35/36-98A 4718 Cumberland Ct.
Chevy Chase (Somerset HD)

SITE PLAN - INDEX - DEMOLITION
SUNDERLAND KOWARICK RESIDENCE
4718 CUMBERLAND AVENUE
CHEVY CHASE MARYLAND

HISTORIC PRESERVATION COMMISSION STAFF REPORT

Address: 4718 Cumberland Avenue Meeting Date: 2/11/98
Resource: Somerset Historic District Review: HAWP
Case Number: 35/36-98A Tax Credit: No
Public Notice: 1/28/98 Report Date: 2/4/98
Applicant: Dr. Trey Sunderland Staff: Robin D. Ziek
PROPOSAL: Rear Addition RECOMMENDATIONS: **APPROVAL
w/CONDITIONS**

ELEVATION FACING CUMBERLAND AVENUE

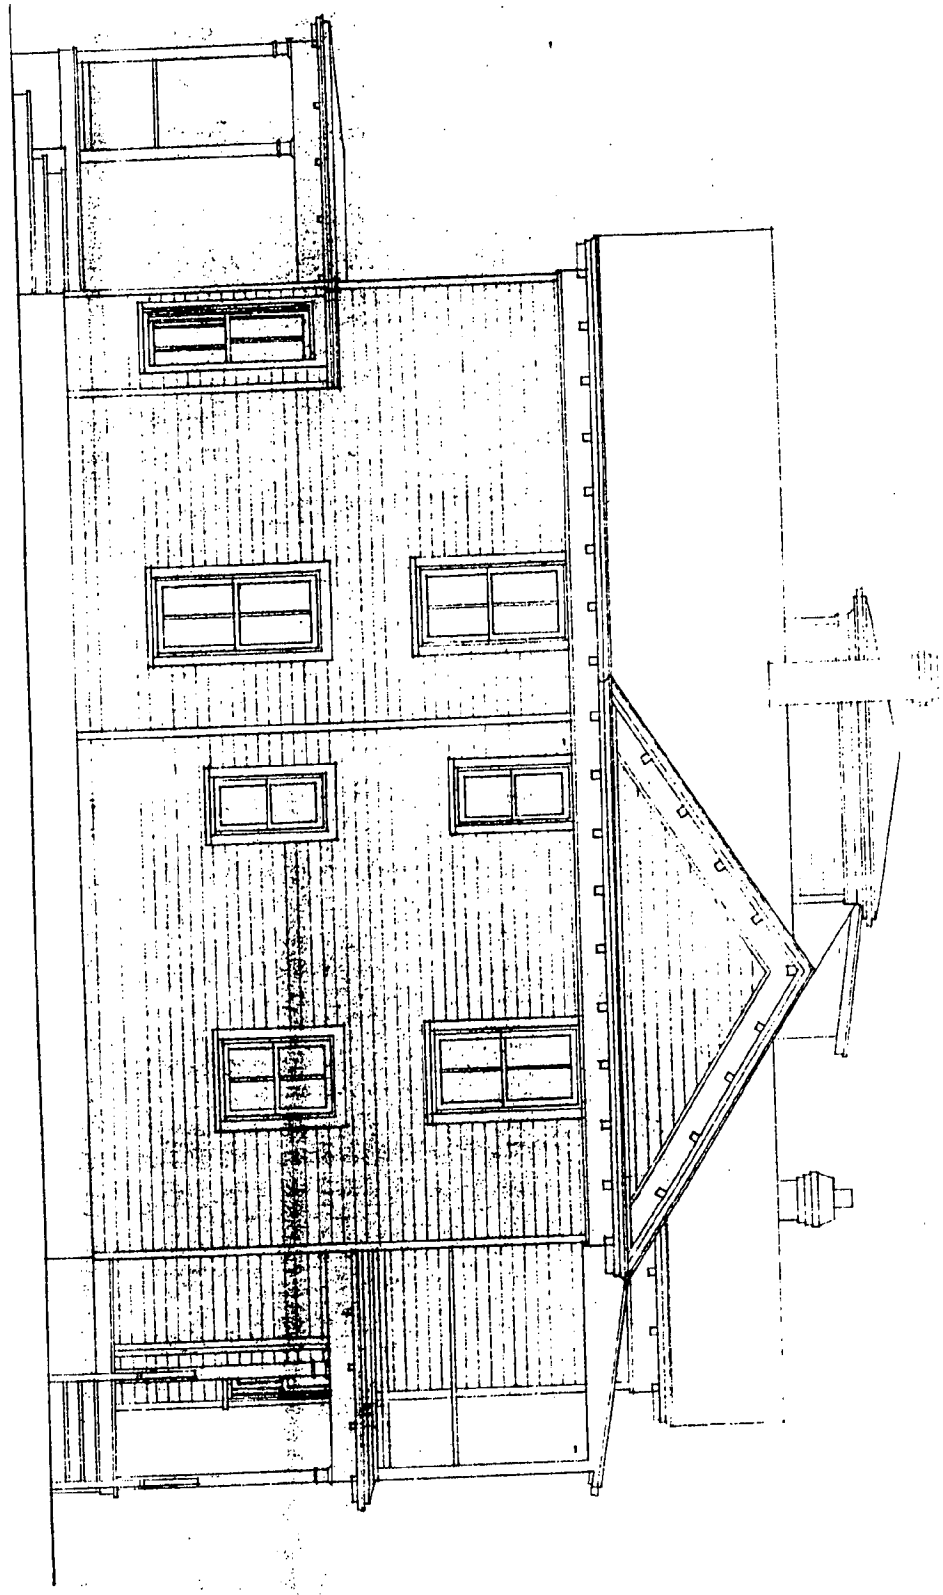
The proposed north elevation indicates the use of a railing on the screened porch (see Circle 19), but with a different screening system on the east elevation and no railing at all (see Circle 25). Staff has discussed with the applicant and with the applicant's architect the possibility of continuing the use of the railing around the entire screened porch, to maintain a unified vocabulary in the addition which would complement the original structure. There is agreement that this is an acceptable option.

1. The new wood lap siding will be a different lap than the original dimension.
2. The new screened porch will utilize a railing system which is compatible with the existing railing system, with inset pickets.

EXISTING WEST

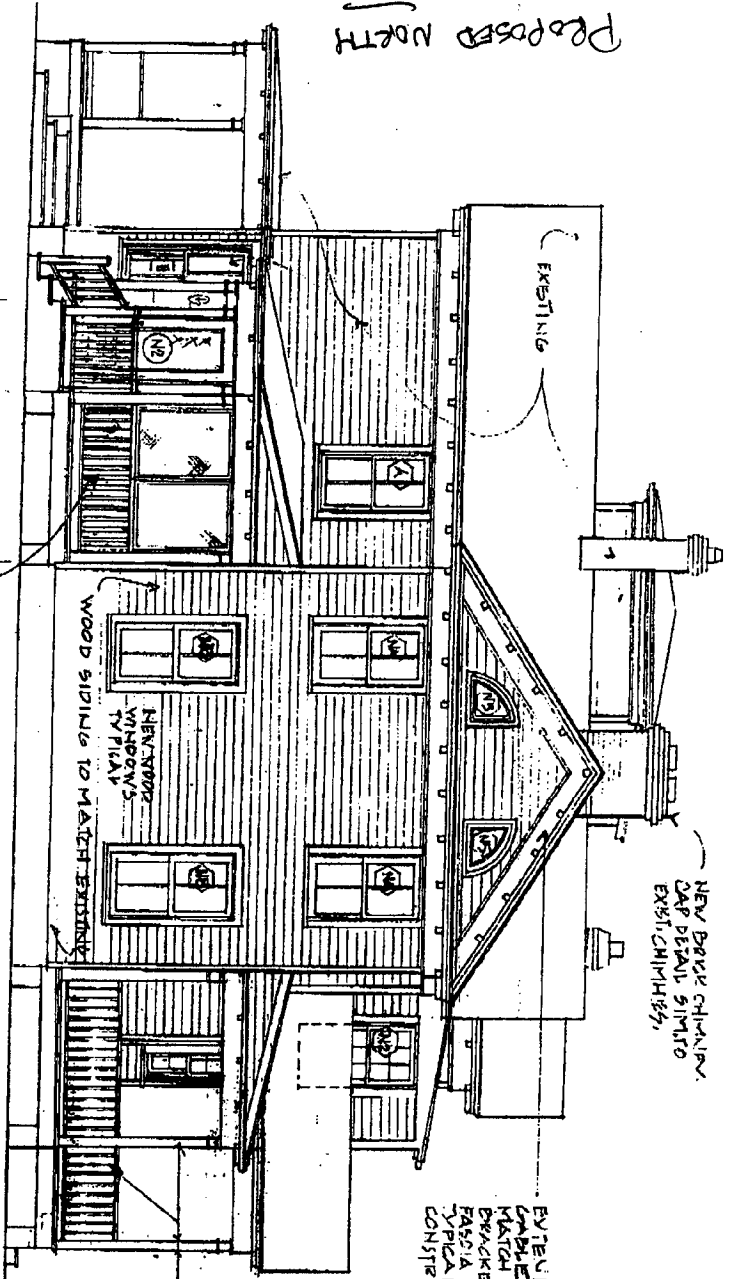
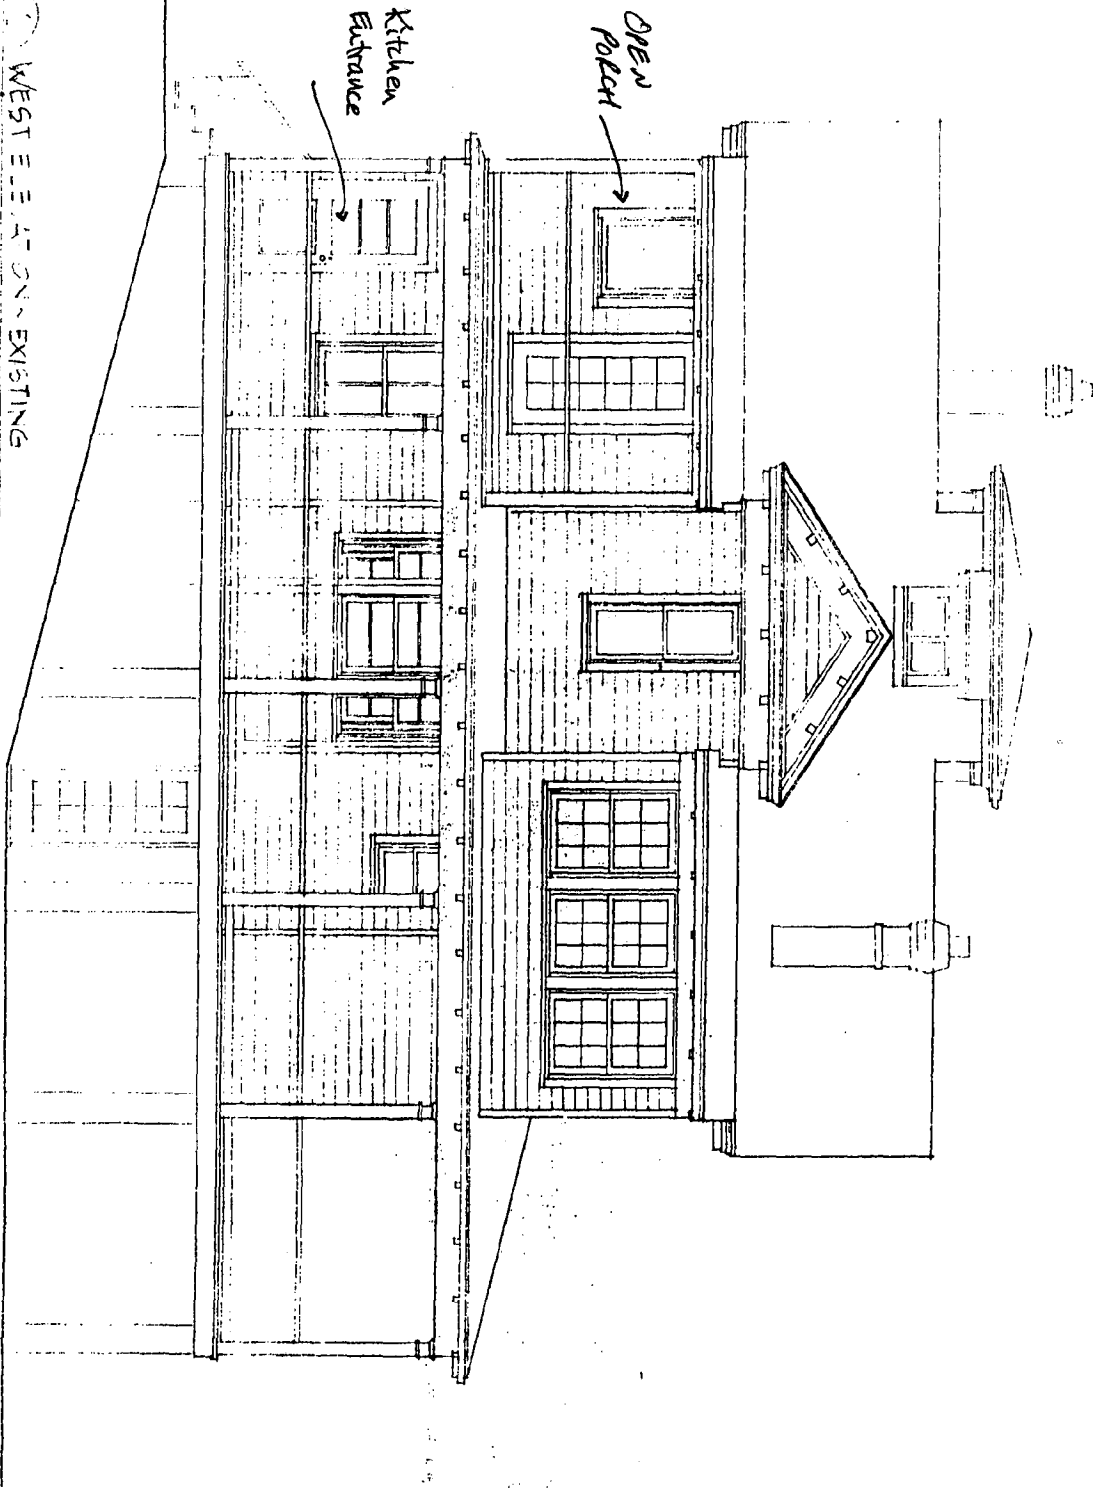
The proposed east and west elevations (see Circles 26, 21) are very long. It is important to project this proposal into three dimensions, and note the setback of the addition from the east elevation which is over 12'. The addition is essentially a rear ell, which fronts Cumberland Avenue. Due to the large size of the lot, the new addition will still sit back 78' from the street. This is significantly farther back than the typical house in Somerset which fronts a street with a setback varying from 30' - 45'. Essentially, the subject property does not front any street, but sits in isolation on a large lot in the middle of Somerset. (See Circle 10 .)

PROPOSED WEST

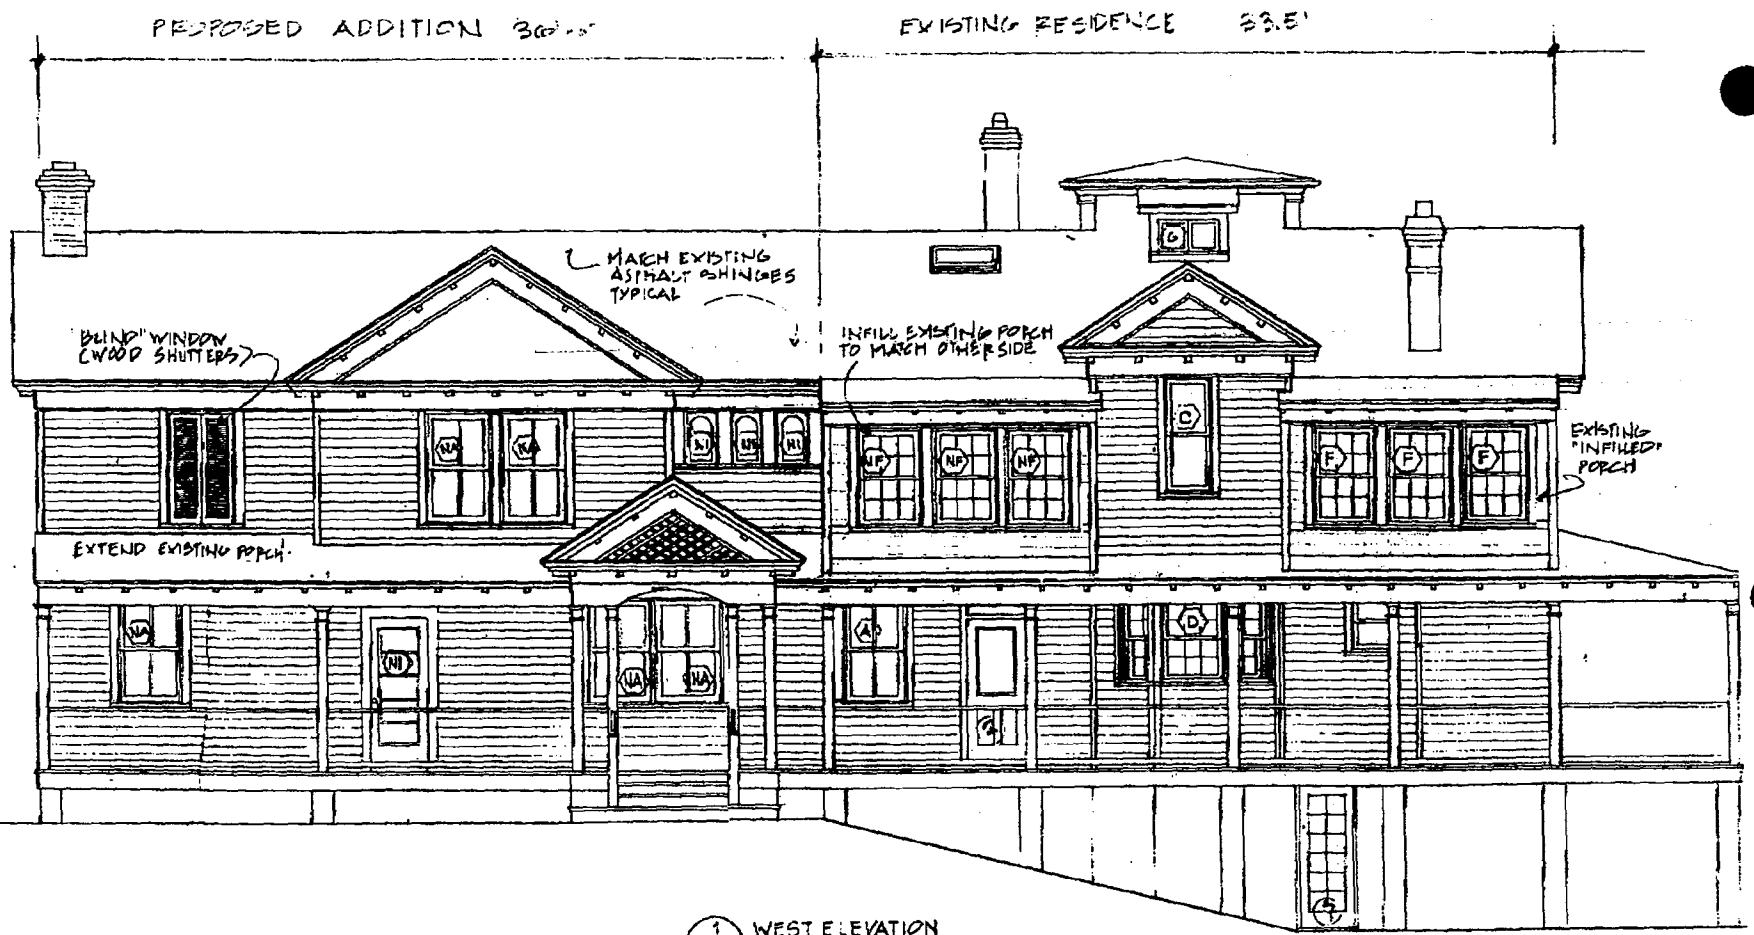
5. NO skylight (as shown on Chale 21) on 2nd. portion of house, and subject to the general condition that the applicant arrange for a field inspection by calling the Montgomery County Department of Permitting Services (DPS), Field Services Office, five days prior to commencement of work and within two weeks following completion of work.
